From: WILLIFORD Dennis (AREVA) [Dennis.Williford@areva.com]
Sent: Wednesday, June 26, 2013 2:07 PM
To: Snyder, Amy
Cc: Miernicki, Michael; ANDERSON Katherine (EXTERNAL AREVA); DELANO Karen (AREVA); HONMA George (EXTERNAL AREVA); LEIGHLITER John (AREVA); LEWIS Ray (EXTERNAL AREVA); ROMINE Judy (AREVA); RYAN Tom (AREVA); SHEPHERD Tracey (AREVA); VANCE Brian (AREVA); ABAYAN Victor (AREVA); LOSEKE Brian (AREVA)
Subject: Advanced Response to U.S. EPR Design Certification Application RAI No. 376, FSAR Ch. 3, Question 03.08.05-31
Attachments: RAI 376 Advance Response Q3.8.5-31 - US EPR DC.pdf

Attached is an Advanced Response for RAI 376, Question 03.08.05-31 prior to the August 30, 2013 final response date.

From: WILLIFORD Dennis (RS/NB)
Sent: Tuesday, February 21, 2012 9:27 PM
To: Getachew.Tesfaye@nrc.gov
Cc: BENNETT Kathy (RS/NB); DELANO Karen (RS/NB); ROMINE Judy (RS/NB); RYAN Tom (RS/NB)
Subject: Response to U.S. EPR Design Certification Application RAI No. 376, FSAR Ch. 3, Supplement 32

U.S. EPR FSAR Tier 2, Sections 3.7.1, 3.7.2, 3.8.4, 3.8.5, Appendix 3E.3, Tables 3.7.2-28, and 3.8-19, and Figures 3.7.2-71, 3.7.2-72, 3.7.2-73, 3.7.2-101, 3.7.2-102, 3.7.2-103, 3.7.2-148, 3.7.2-14

Figure 3.7.2-71—Soil Model Surface Response Spectra at Centers of Footprint of EPGB - 5% Damping, X-Direction

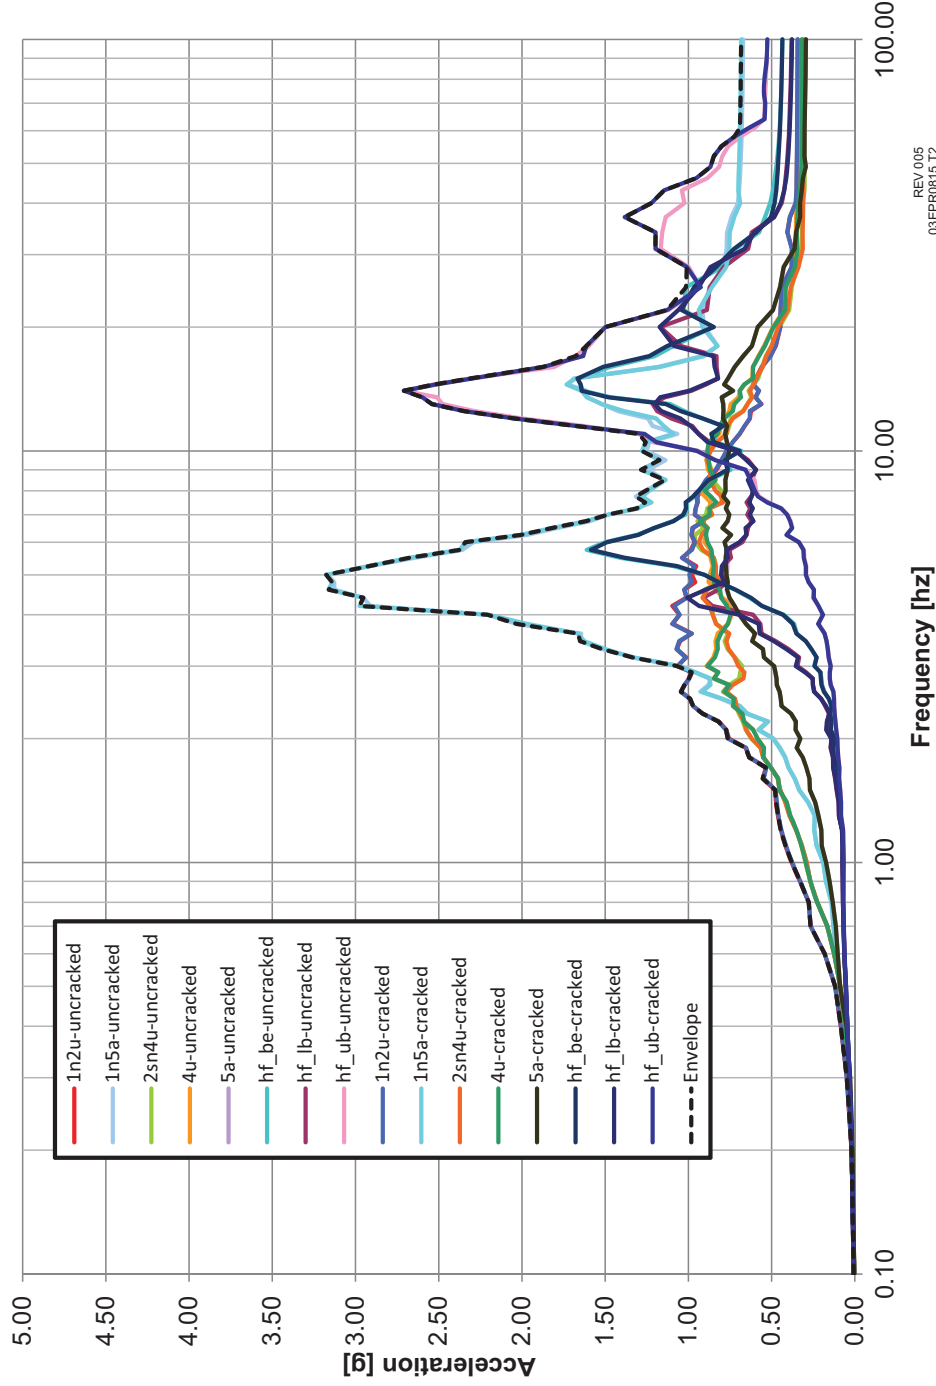
Figure 3.7.2-71—Soil Model Surface Response Spectra at Centers of Footprint of EPGB - 5% Damping, X-Direction, Figure 3.7.2-72—Soil Model Surface Response Spectra at Centers of Footprint of EPGB - 5% Damping, Y-Direction, and Figure 3.7.2-73—Soil Model Surface Response Spectra at Centers of Footprint of EPGB - 5% Damping, Z-Direction show the 5 percent damping response spectra of the response motions from all SSI analysis cases at the soil model surface (i.e., elevation -38 ft, 10-1/2 inches) at the center nodes of the footprints of EPGB 1 and 2 and ESWB 1 to 4. Figure 3.7.2-158—Soil Model Surface Response Spectra at Centers of Footprint of ESWB - 5% Damping, X-Direction, Figure 3.7.2-159—Soil Model Surface Response Spectra at Centers of Footprint of ESWB - 5% Damping, Y-Direction, and Figure 3.7.2-160—Soil Model Surface Response Spectra at Centers of Footprint of ESWB - 5% Damping, Z-Direction show the five percent damping response spectra of the response motions from all SSI analysis cases at the center nodes of the footprints of ESWB 1 to 4. These response spectra are used as the basis for developing the modified CSDRS discussed in Section 3.7.2.1.1 for use as seismic input to the SSI analysis of the EPGB and ESWB.

Figure 3.7.2-101—Spectrum Envelope of EPGB at the Center of Basemat -
2%, 3%, 4%, 5%, 7%, and 10% Damping, X-Direction

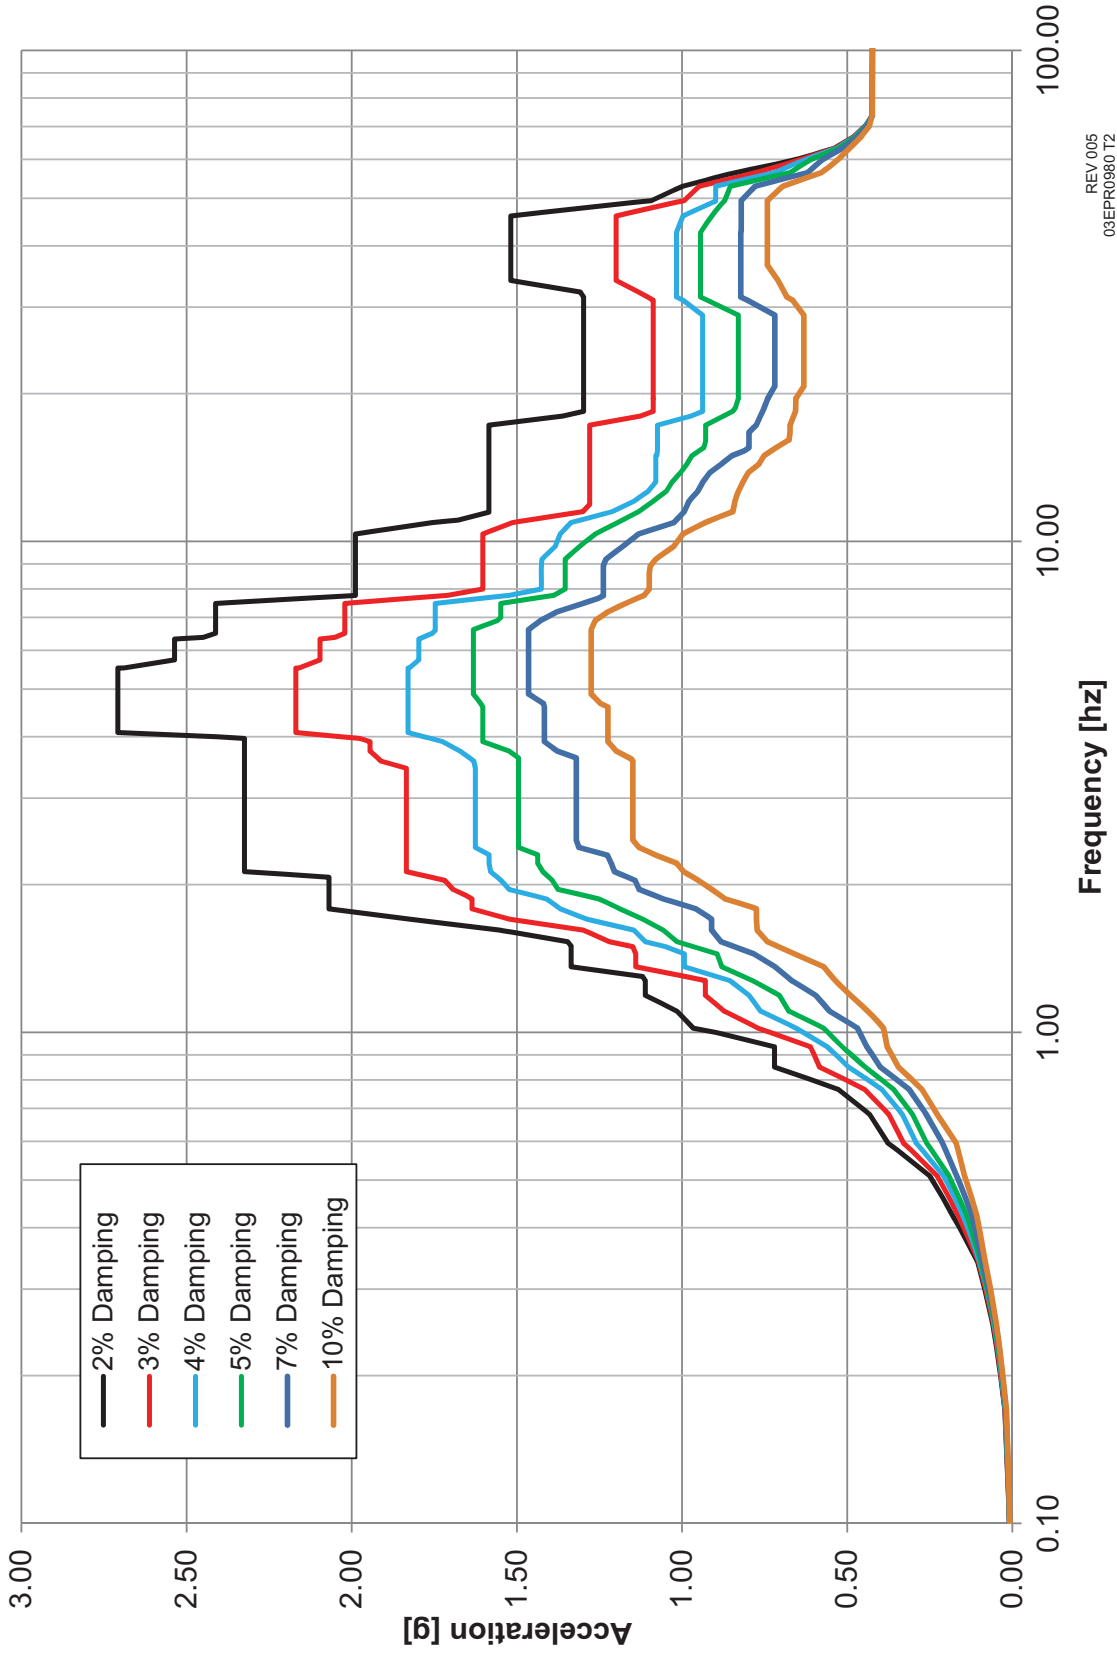
Figure 3.7.2-101—Spectrum Envelope of EPGB at the Center of Basemat - 2%, 3%, 4%, 5%, 7%, and 10% Damping, X-Direction, Figure 3.7.2-102—Spectrum Envelope of EPGB at the Center of Basemat - 2%, 3%, 4%, 5%, 7%, and 10% Damping, Y-Direction, and Figure 3.7.2-103—Spectrum Envelope of EPGB at the Center of Basemat - 2%, 3%, 4%, 5%, 7%, and 10% Damping, Z-Direction show the peak-broadened and smoothed ISRS envelopes at elevation -6 ft, 0 inches of the EPGB.

Figure 3.7.2-148—Spectrum Envelope of EPGB at Elev. +50⁴ ft, 6 in - 2%, 3%, 4%, 5%, 7%, and 10% Damping, X-Direction

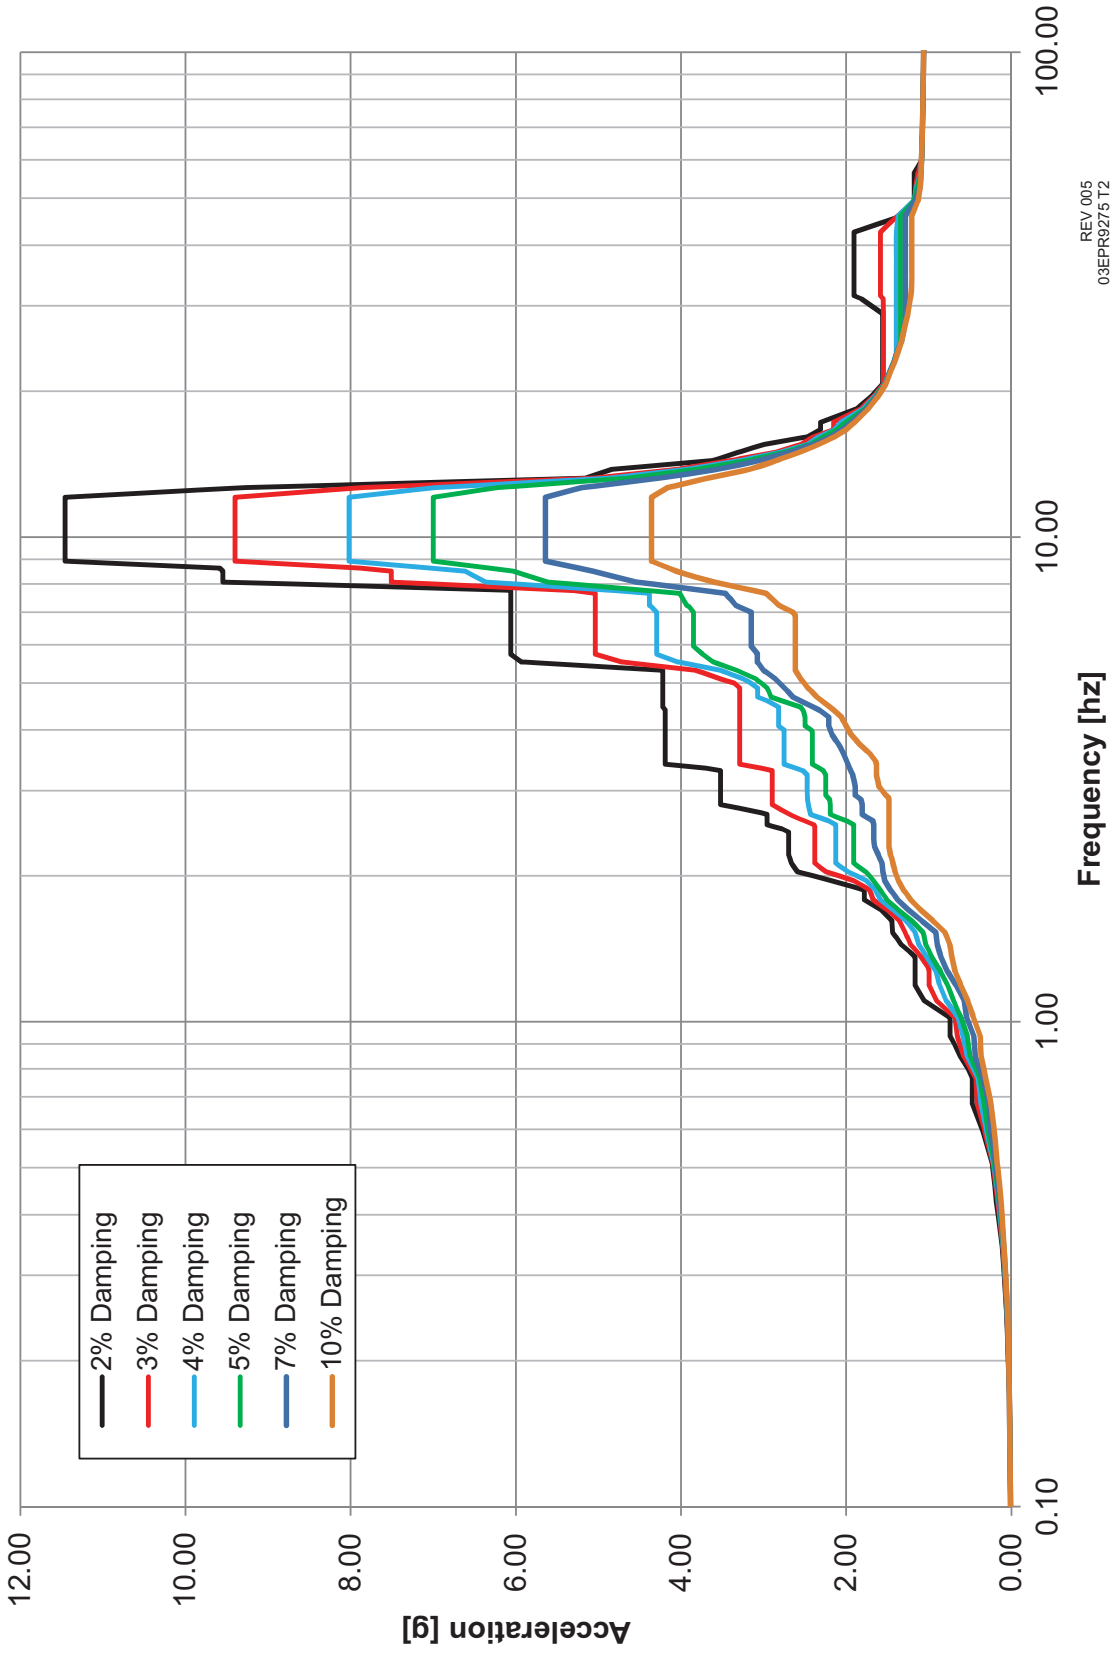
Figure 3.7.2-148—Spectrum Envelope of EPGB at Elev. +51 ft, 6 in - 2%, 3%, 4%, 5%, 7%, and 10% Damping, X-Direction, Figure 3.7.2-149—Spectrum Envelope of EPGB at Elev. +50± ft, 6 in - 2%, 3%, 4%, 5%, 7%, and 10% Damping, Y-Direction, and Figure 3.7.2-150—Spectrum Envelope of EPGB at Elev. +50± ft, 6 in - 2%, 3%, 4%, 5%, 7%, and 10% Damping, Z-Direction show the peak-broadened and smoothed ISRS envelopes on elevation +50± ft, 6 inches of the EPGB.
